Baltimore Gas and Electric Company
Calvert Cliffs Nuclear Power Plant
1650 Calvert Cliffs Parkway
Lusby, Maryland 20657
410 586-2200 Ext. 4455 Local
410 260-4455 Baltimore

September 11, 1995

SUBJECT: Calvert Cliffs Nuclear Power Plant
Unit No. 1; Docket No. 50-317
Supplemental Information; Request for Temporary Relief from ASME Boiler &
Pressure Vessel Code Section XI Requirement IAW-5250

COUPLING THROUGH
WALL NON CODE REPAIR

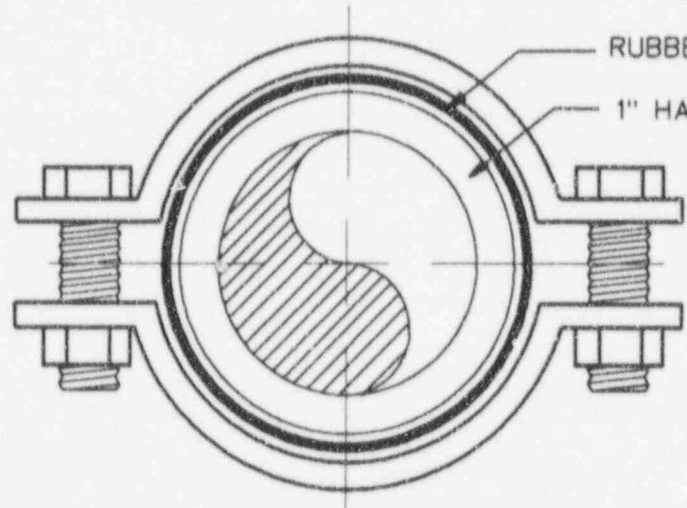
In order to prevent leakage into the service water room from the continued degradation of the half-coupling, we plan to install a rubber-lined pipe clamp around the flawed portion of the half-coupling (see Attachment 1) should the leakage significantly increase. The clamp will have no effect on the structural integrity of the 36" saltwater pipe, and is a reversible leakage limiting device.
